Responses to MAC#10 Recommendations

Vadim Ptitsyn

C-AD, MAC 11

December 8-10, 2014

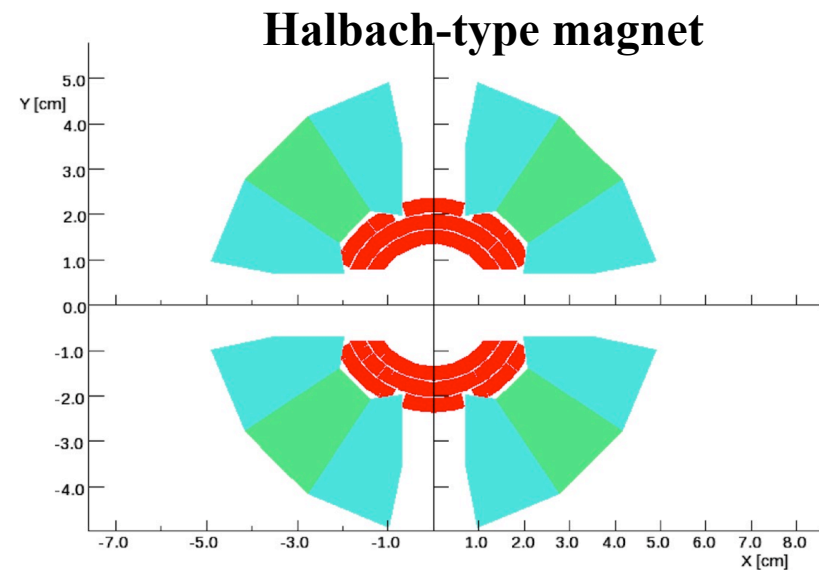
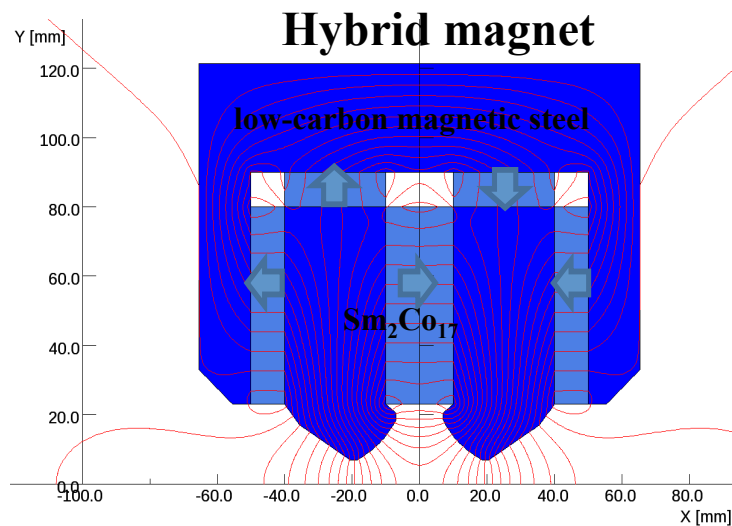
- Obtain specifications on the higher field harmonics from the eRHIC beam dynamics group and perform comparative analysis of the magnet field quality all over the FFAG orbit range in 3D, including edge effects.
- One round of simulations with ZGOUBI to evaluate initial tolerances on the high field harmonics has been done. (Tolerances are at the level few units 10^{-4} at 1cm). More thorough simulation studies are on-going.
- Build a prototype magnet and measure the field quality and temperature stability.
 - Permanent magnet prototypes (for 3-4 possible designs) will be built in 2015.

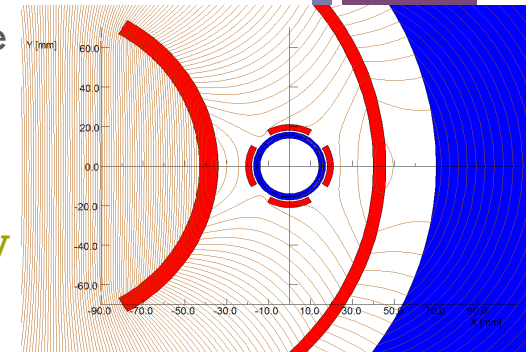
- The study presented so far is preliminary IP conceptual design. The dynamic aperture is also preliminary. More work is needed to optimize the IR design.

- Committee members are not fully convinced that betatron wave created in the arc will provide a better high order chromatic aberration.
- The electron interaction region needs to be designed and the effects mentioned above evaluated.

- IR design presented at MAC#10 has been modified. Modified design employs new ideas (B.Parker) of arranging electron field-free pass through the SC coil area of hadron magnets. New design has not been fully completed yet. DA studies are still to be done.

e-beam passage arranged at “sweet” spot between SC coils
